BY JOHNSON CONTROLS

SI0227

Equipment Affected: YK Centrifugal Chillers with OptiSpeed VSDs

Quick Start Feature – Product Overview and Ordering Information

Style D Quick Start Modification for UPS

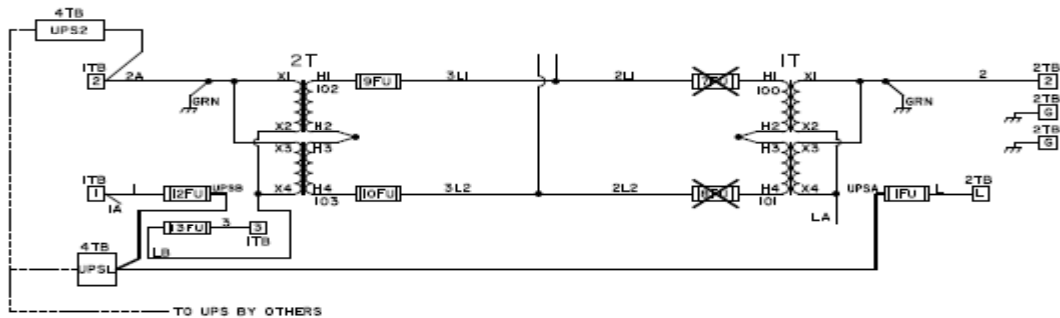
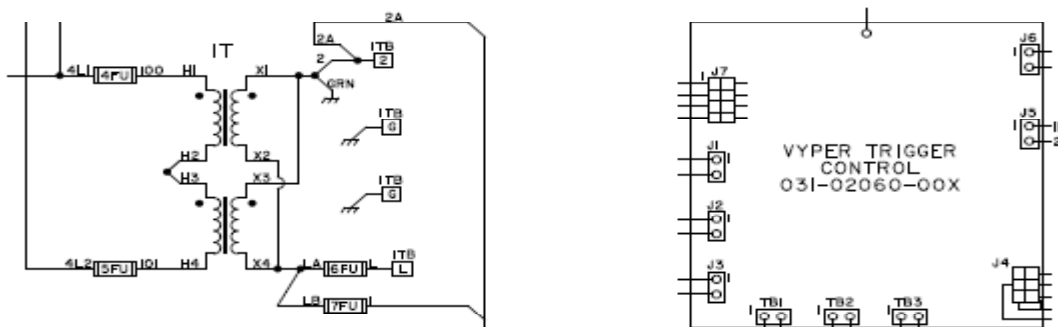
- Remove and discard fuses 7FU and 8FU
 - Remove wire LA from 11FU fuseholder and attach male terminal (item 4) to wire LA
 - Remove wire 1A from 13FU fuseholder and attach male terminal (item 4) to wire 1A

- Remove wire LB from 12FU fuseholder and attach wire LB to 13FU fuseholder
 - Remove cover plate and gasket from the 2” hole between the 1T and 2T control transformers. Discard blank cover plate. Keep gasket and hardware, they will be reused.

- Attach new cover plate (item 1) reusing gasket and secure with original hardware.
 - Attach terminal block (item 2) onto studs located on left inside wall above the fuse swing panel and secure using nuts (item 4)

- Connect stripped end of wire UPS2 (item 3) to left side of terminal block (item 2) at location UPS2. Connect the other end of wire UPS2 to an open location 2 on 1TB terminal block.

- Connect stripped ends of wires UPSA and UPSB (item 3) to left side of terminal (item 2) at location UPSL. Route wires UPSA and UPSB along harness on the fuse swing panel securing with tie wraps (item 5) where appropriate. Attach wire UPSA to 11FU fuseholder. Attach wire UPSB to 12FU fuseholder.

Vyper 351/292/424 HP Quick Start Modification for UPS

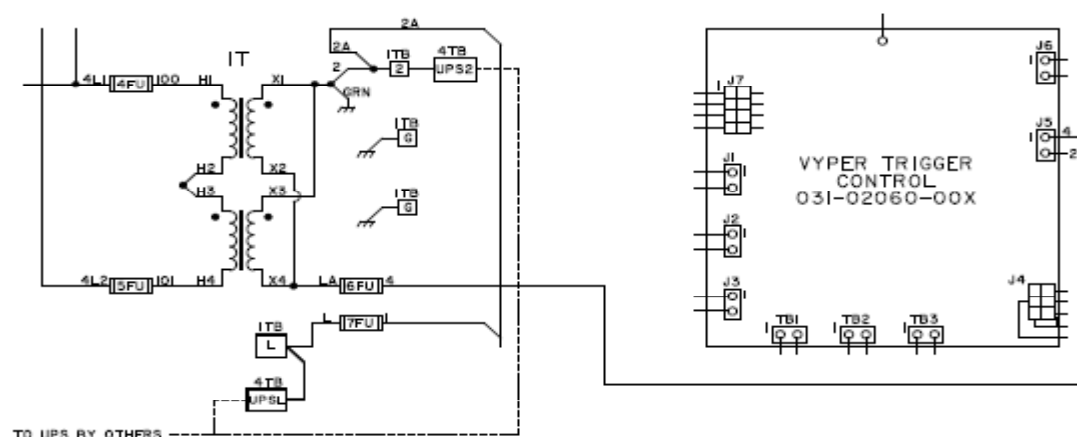
- UPS Vyper 351/292/424 HP (references to “items” below are parts from the kit)
 - o Order wiring modification kits for the VSD
 - o Remove and discard wire LB from the top of 6FU and 7FU

- o Remove wire L from the bottom of 6FU and attach wire L to the top of 7FU
 - o Remove and discard fuse 6FU and replace 6FU with item 6
 - o Remove cover plate and gasket from the conduit access. Discard the old cover plate and keep the gasket.

- o Attach new cover plate (item 1) reusing gasket and secure with original hardware.
 - o Attach terminal block (item 2) onto studs located on left bottom of enclosure and secure using nuts (item 4)

- o Connect stripped end of wire UPS2 (item 3) to left side of terminal block (item 2) at location UPS2. Connect the other end wire UPSL to terminal L of 1TB terminal block.

- o Connect stripped end of wire UPSL (item 3) to left side of terminal block (item 2) at location UPSL. Connect the other end of wire UPSL to terminal L of 1TB terminal block.

- o Connect Faston terminal end of wire 4 (item 3) to the bottom of 6FU. Route wire 4 along main harness to J5 of SCR trigger board (031-02060-XXX) securing with tie wraps (item 5).

- o Remove plug P5 from the SCR trigger board and extract wire 2J. Insert wire 2J into the open position of plug next to wire 4. Connect the new plug containing wires 4 and 2J into J5 on the SCR trigger board. Cap the plug containing wire 1E with housing (item 7) and tuck into main harness.

Vyper 503/608/419 HP Quick Start Modification for UPS

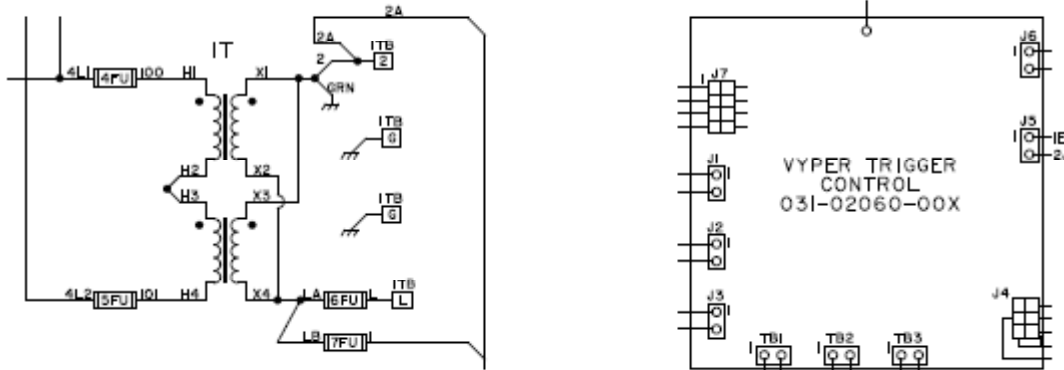
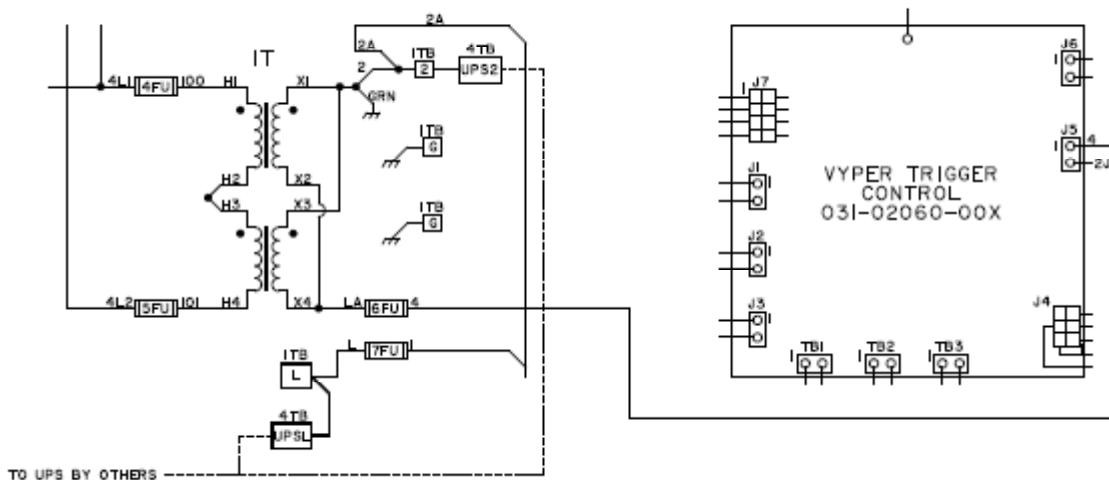
- UPS: Vyper 503/608/419 HP (references to “items” are parts supplied in the kit)
 - o Order wiring modification kits for the VSD
 - o Remove and discard wire LB from the top of 6FU and 7FU

- o Remove wire L from the bottom of 6FU and attach wire L to the top of 7FU
 - o Remove and discard fuse 6FU and replace 6FU with item 6
 - o Remove blank cover plate and gasket from the lower middle left wall of the enclosure. Discard the blank cover plate and keep the gasket and hardware.

- o Attach new cover plate (item 1) reusing gasket and secure with original hardware.
 - o Attach terminal block (item 2) onto studs located on left bottom of enclosure and secure using nuts (item 4)

- o Connect stripped end of wire UPS2 (item 3) to left side of terminal block (item 2) at location UPS2. Connect the other end wire UPSL to terminal L of 1TB terminal block.

- o Connect stripped end of wire UPSL (item 3) to left side of terminal block (item 2) at location UPSL. Connect the other end of wire UPSL to terminal L of 1TB terminal block.

- o Connect Faston terminal end of wire 4 (item 3) to the bottom of 6FU. Route wire 4 along main harness to J5 of SCR trigger board (031-02060-XXX) securing with tie wraps (item 5).

- o Remove plug P5 from the SCR trigger board and extract wire 2J. Insert wire 2J into the open position of plug next to wire 4. Connect the new plug containing wires 4 and 2J into J5 on the SCR trigger board. Cap the plug containing wire 1E with housing (item 7) and tuck into main harness.

OptiView to OptiSpeed Wiring (Modbus Protocol new wiring)

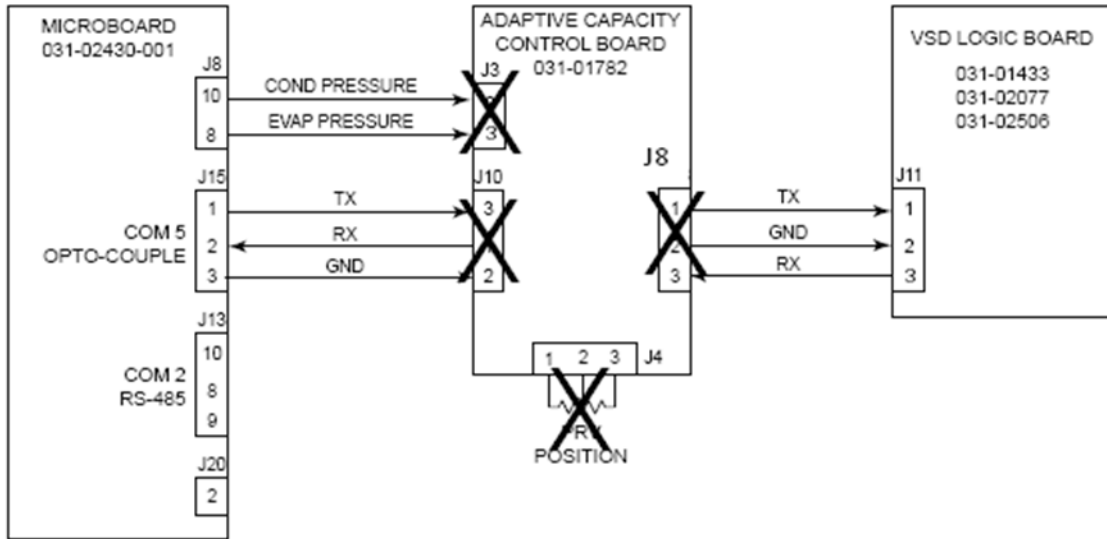
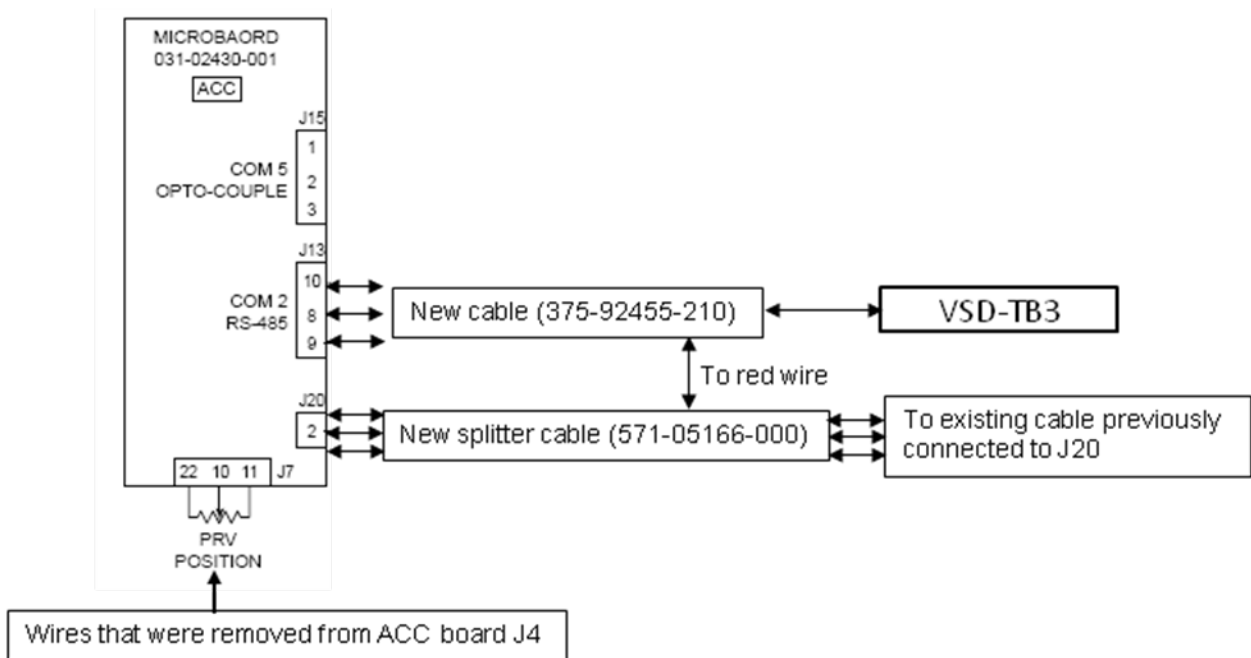
- o Remove J4 connector from ACC board (ACC Board functionality is incorporated in the new 031-02430-001 board). Remove wires/pins from J4 connector and insert into J7 Microboard connector. The following are the new pin locations: J7-22 (red wire), J7-10 (white wire), J7-11 (black wire).

- o Remove J3, J6, J8, J9, and J10 connectors from ACC Board.
- o Remove the J20 cable connector from the 031-02430-001 board.
- o Install the removed J20 connector into the J20 adaptor cable (571-05166-000).

- o Insert the new P20 connector on the J20 adaptor cable into Microboard J20 connector.
- o Install OptiView end of J13-3TB cable (375-92455-210) to J13 (Com 2) connection on Microboard per the following: green wire into J13-10, black wire into J13-9, and white wire into J13-8. Connect the forked lug to panel ground near J13.

- o Remove OptiView wiring from 3TB. Tape off wiring. It may be needed in the future to convert back to York Protocol.
- o Route J13-3TB cable (075-92455-210) to VSD 3TB

- o Install wiring on 3TB per 035-21563-000.

- o Place Microboard JP-17 on pins 1-2
- o Place JP-3 on 031-02506-00x VSD Logic Board on one pin for the York application
- o Install new software into the 031-02430-001 Microboard
- o Set Motor Communications Protocol on set-up screen to Modbus
